Subject: Strontium 90 Monitoring - Dave Rogers reply of 12-11-00

HSWA LANL G/MY/HWP/2000

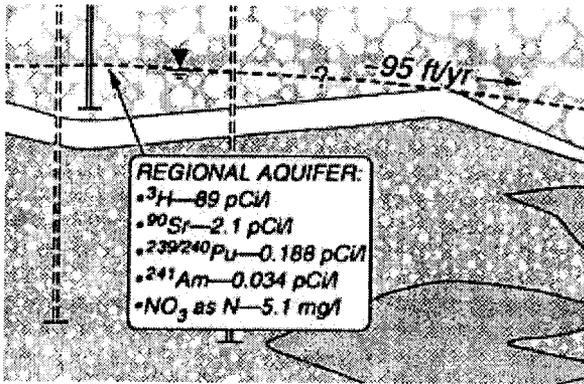
This figure identified the concentration of 2.1 pCi/L of Strontium 90 in the regional aquifer (as well as other COC's such as Plutonium). This value happens to coincide with the 1999 measurement in PM-1. Table 5-22 of this Workplan shows a value of 2.7 pCi/L on 8/13/96 for the "New Community Well". (The one sigma uncertainty is given as 0.6.) In view of the DCG limit of 8, it is admitted that this level is hazardous. Other charts, such as Figure 3-20 of November 1995, show much higher concentrations (perhaps 60 pCi/L) in alluvial groundwater under Los Alamos Canyon from 1990 to 1992.
